ADDENDUM NO. 2

DATE: March 8, 2019
FROM: Village of Villa Park Public Works Department
TO: All Planholders
PROJECT: **North Princeton Avenue Improvements**

PROJECT NO. 140092.00012
 DATE: 3/8/2019
 SHEET 9 OF 22
 DRAWING NO. 9

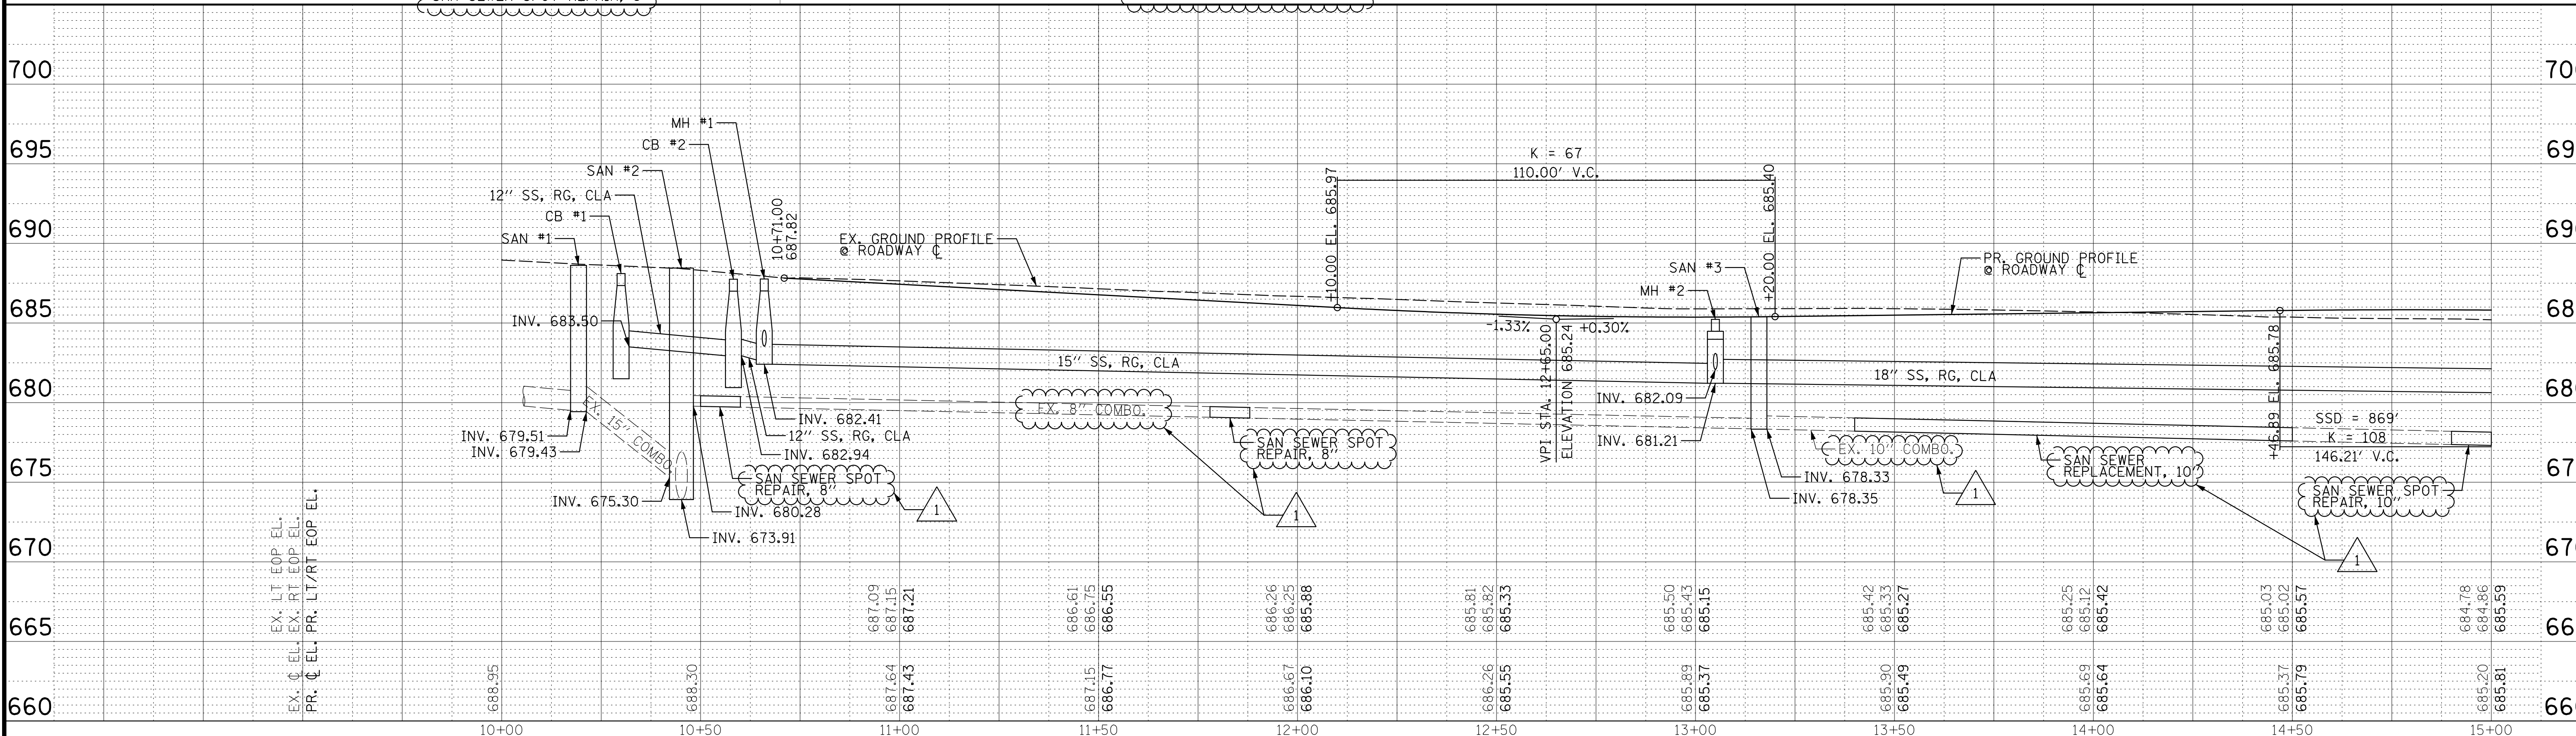
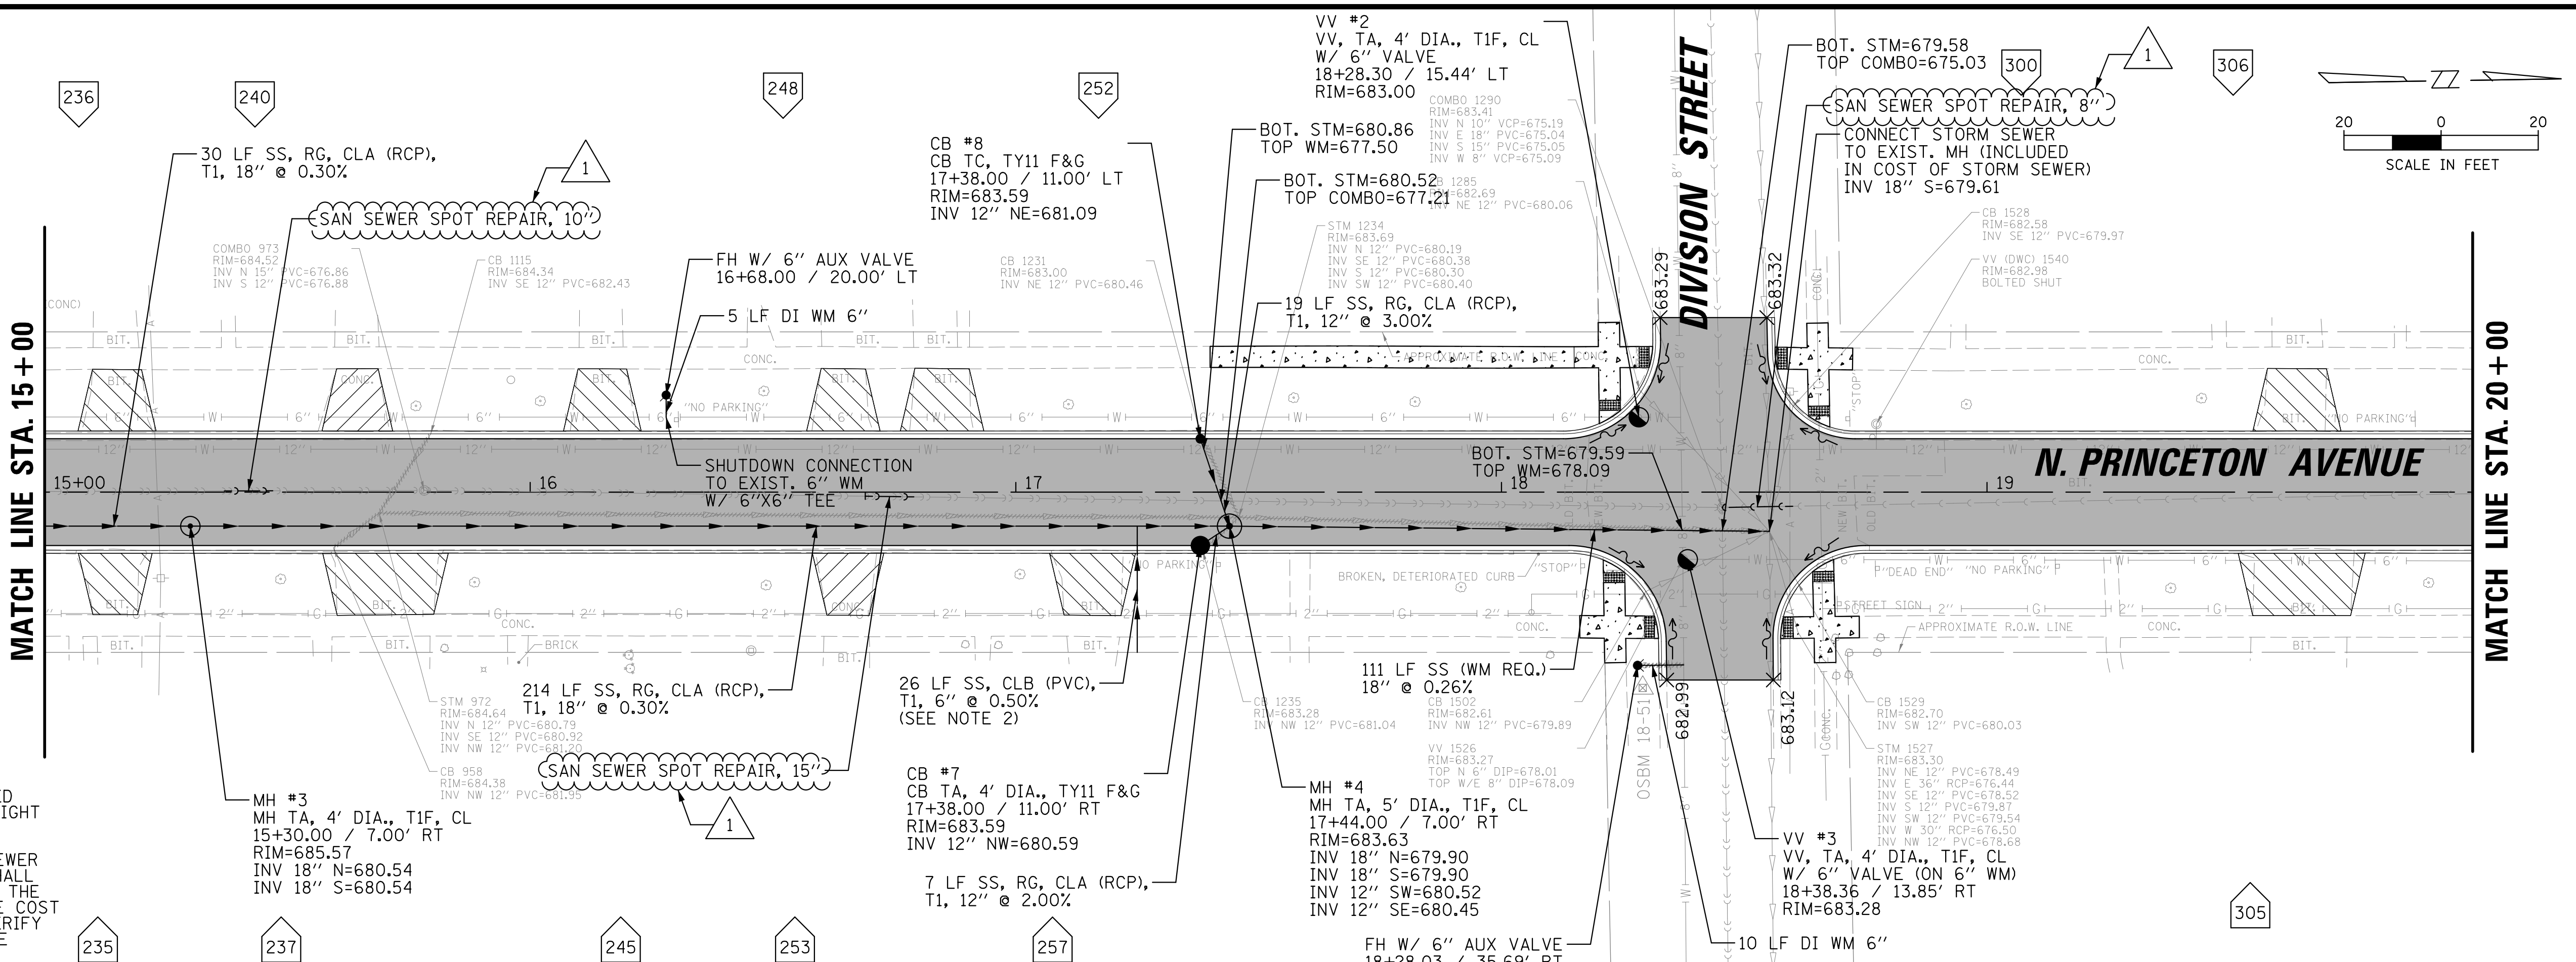
Replace Sheet 9 of the Plans with the attachment included in this addendum. Revisions were made to the pipe diameters of the existing combined sewers and the proposed diameter of manhole SAN #2. Approximate locations of the sanitary sewer spot repairs and sanitary sewer replacement have been added to the plan and profile. The revisions are bubbled on the plan sheet.

| PLOT DATE: | 3/8/2019 | SHEET 10 OF 22 |

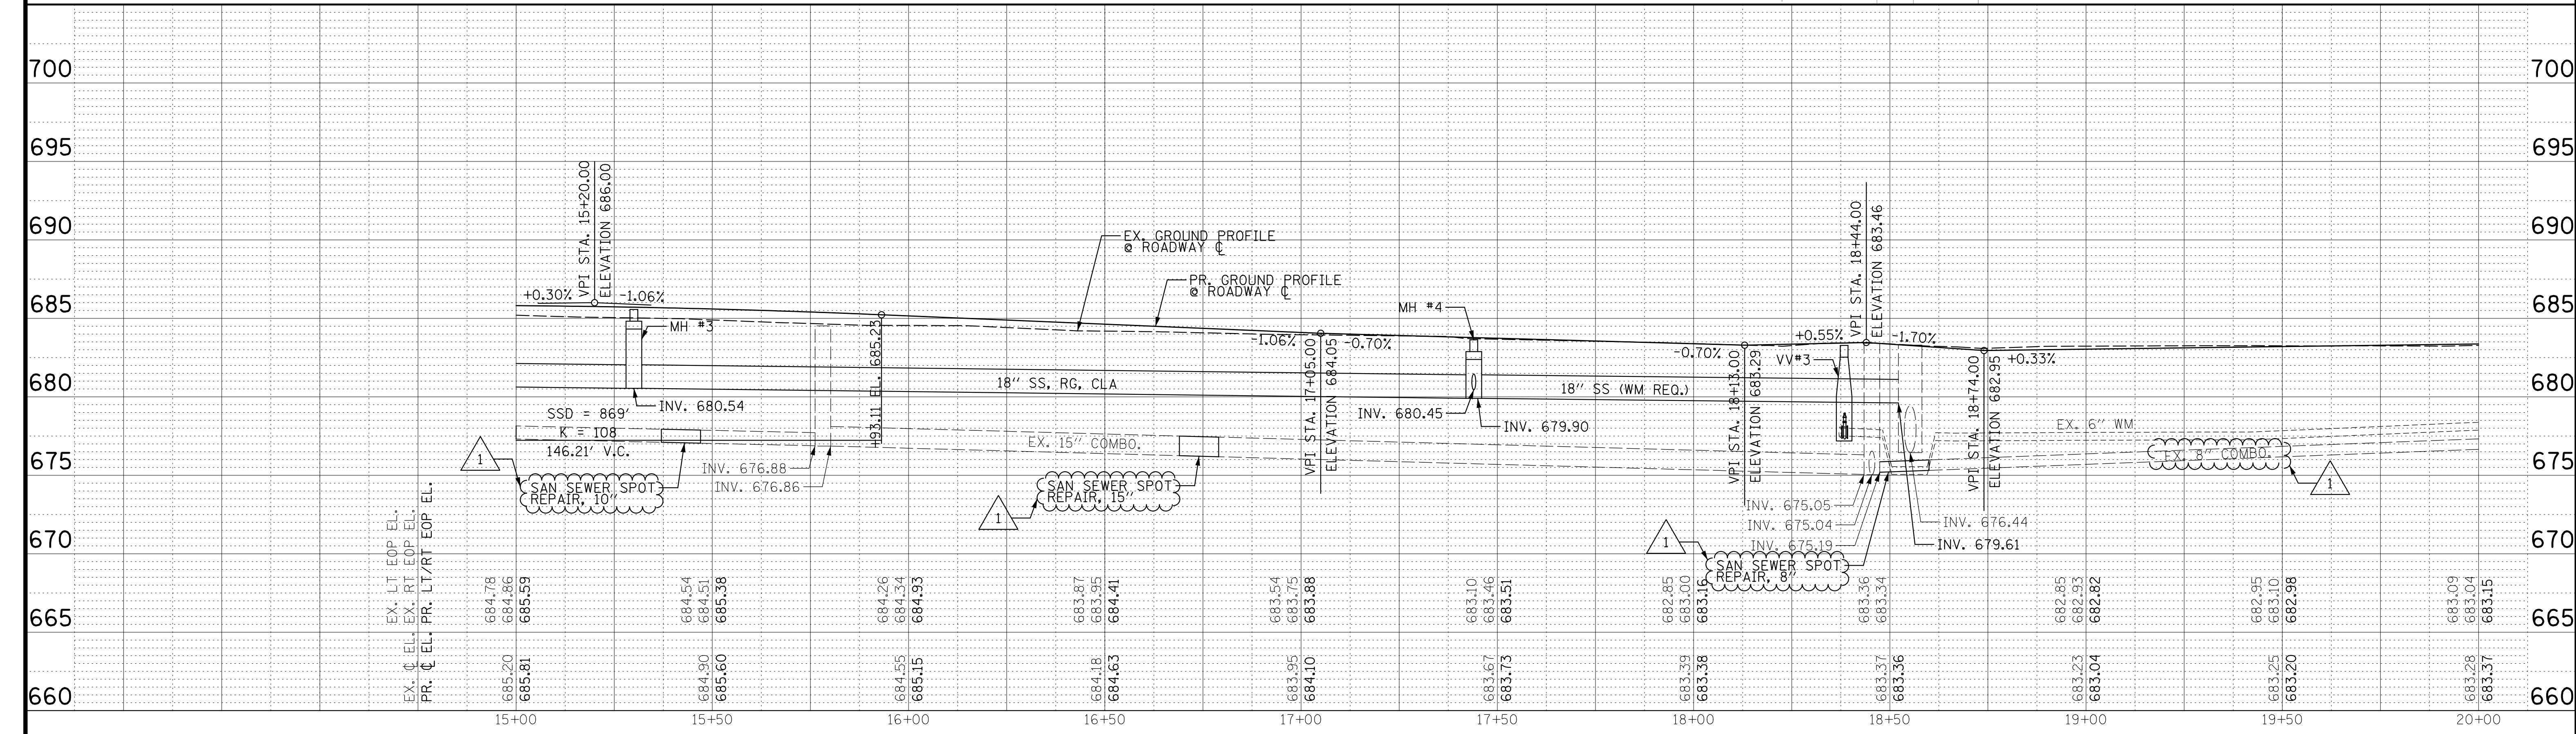
Replace Sheet 10 of the Plans with the attachment included in this addendum. Revisions were made to the pipe diameters of the existing combined sewers. Approximate locations of the sanitary sewer spot repairs have been added to the plan and profile. The revisions are bubbled on the plan sheet.

| SHEET 11 OF 22 | DRAWING NO. |

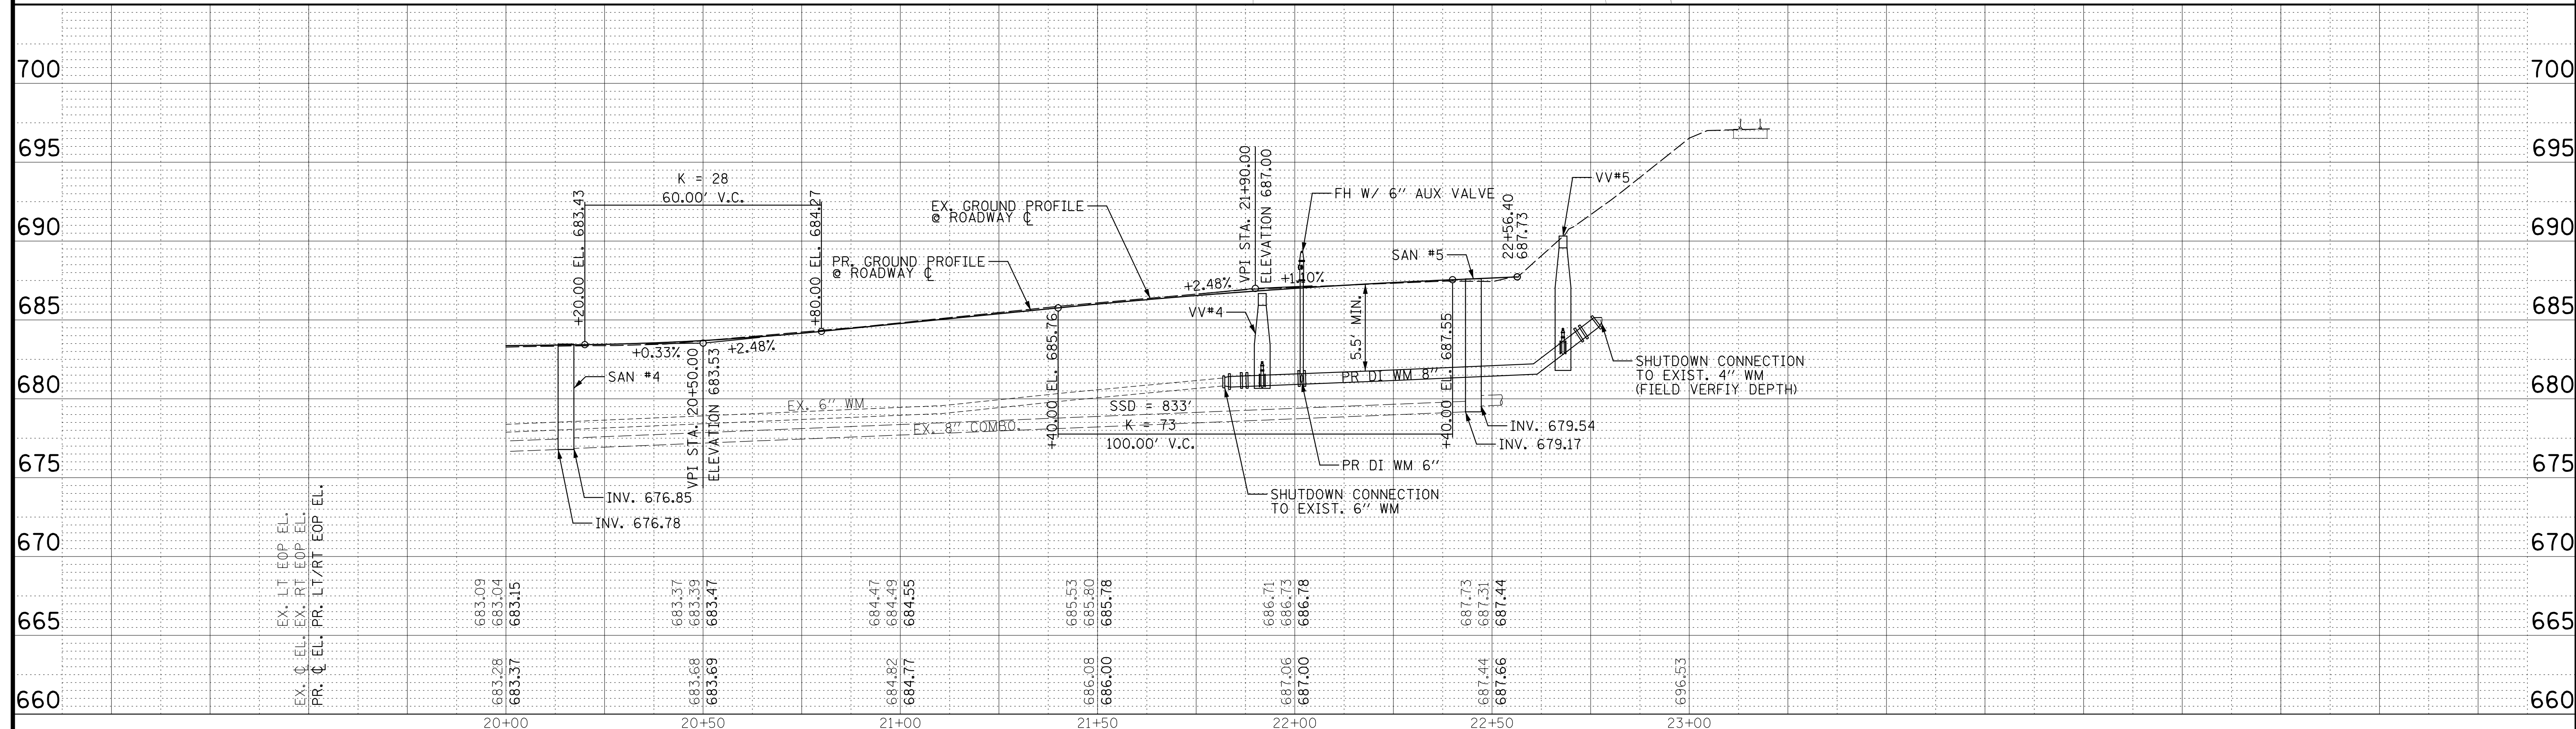
Replace Sheet 11 of the Plans with the attachment included in this addendum. Revisions were made to the pipe diameters of the existing combined sewers. The revisions are bubbled on the plan sheet.
